ADDENDUM NO. 2

TO THE DRAWINGS AND SPECIFICATIONS
FOR THE
Tates Creek High School Track & Field Improvements
2/9/2023

TATES CREEK HIGH SCHOOL TRACK & FIELD IMPROVEMENTS
ADDENDUM #2 – MEP **2/9/2023**

Item #1 Refer to the Electrical Drawing UE1.0

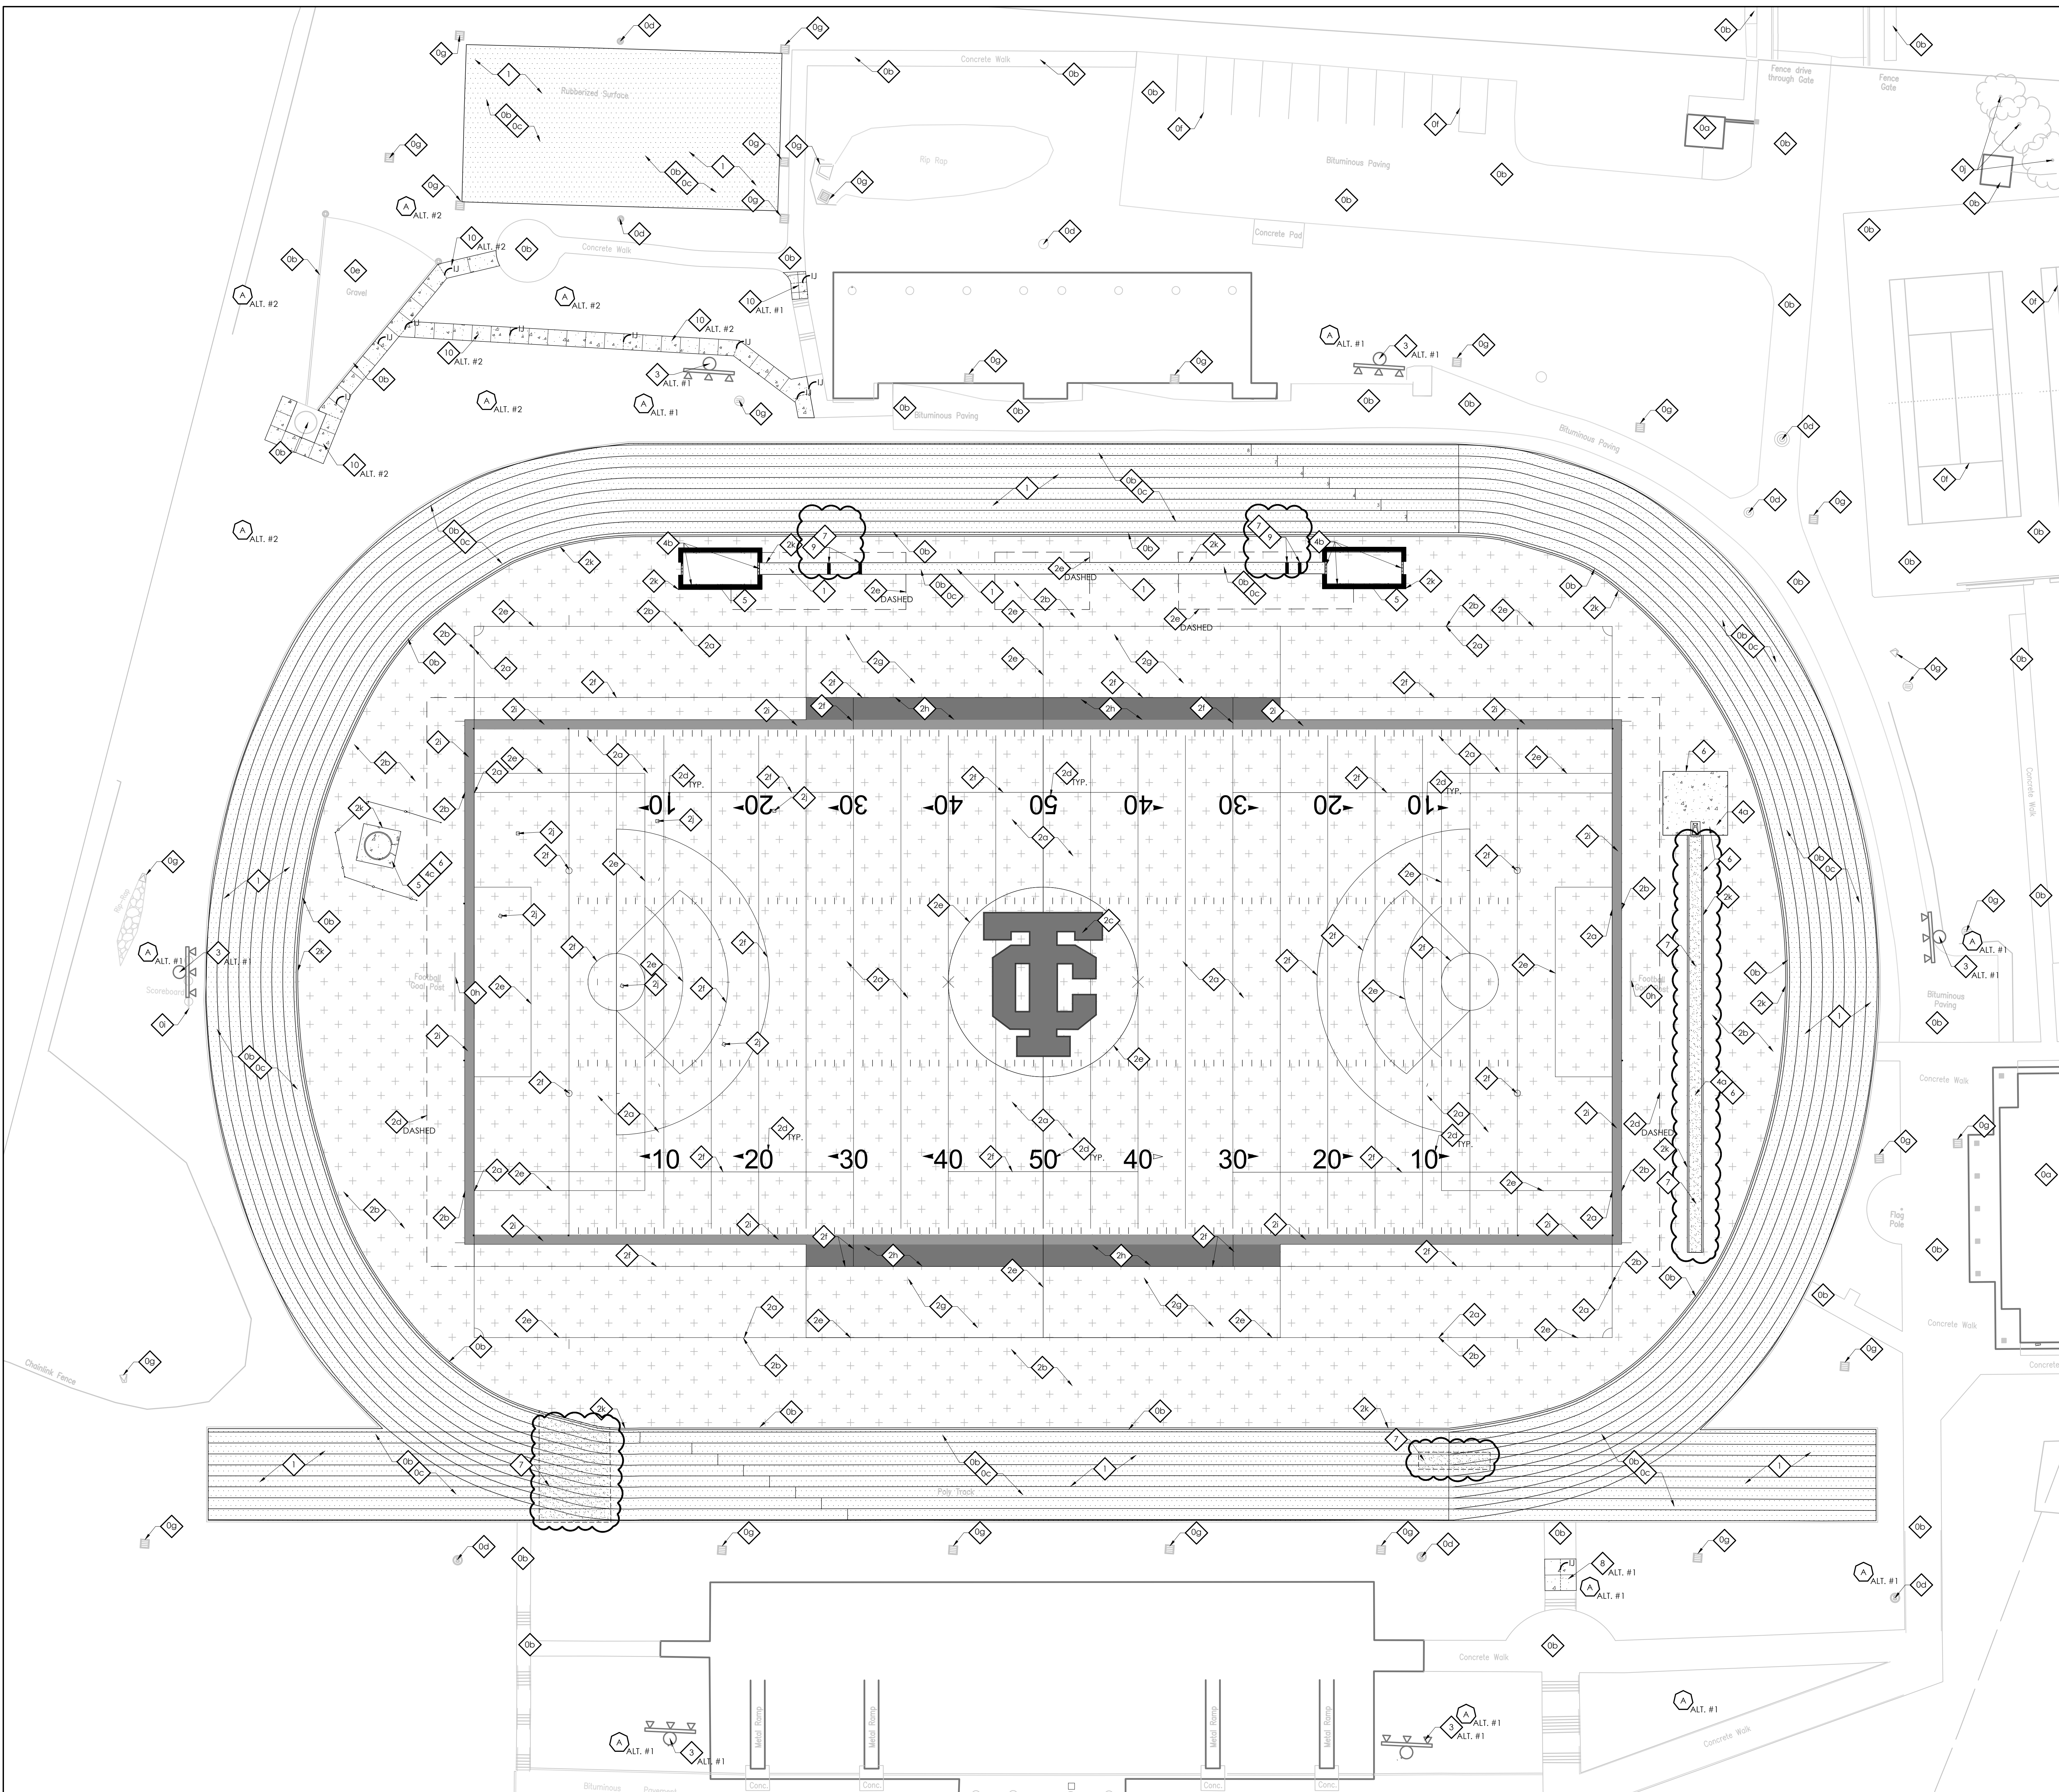
- A. Tagged Note U16 shall read as follows: REMOVE EXISTING ATHLETIC LIGHTING. REMOVE CONDUITS AND FOUNDATION TO 18" MINIMUM BELOW GRADE. REMOVE CONDUCTORS.
